UN-ECE R93-00

OICA comments to proposal from EC
per document

ECE/TRANS/WP.29/GRSG/2019/19

R93 Amendment Proposal

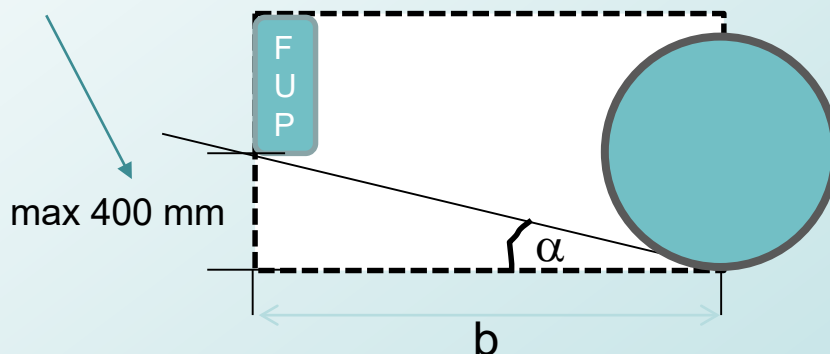
- Removable FUP would anyway **not** be **applicable in the real world**:
 - Handling time would severely affect the productive working time
 - Existing removable FUP are usually not used again after having been removed since they are affected by the handling itself
- The logics of UN R73 or UN R58 cannot apply to UN R93.
 - UN R73 (Lateral Underrun Protection) does **not refer to off-road** vehicle - “G” category
 - UN R58 (Rear Underrun Protection) **addresses the rear** of the vehicle:
 - Backed by accidentology
 - Technically feasible
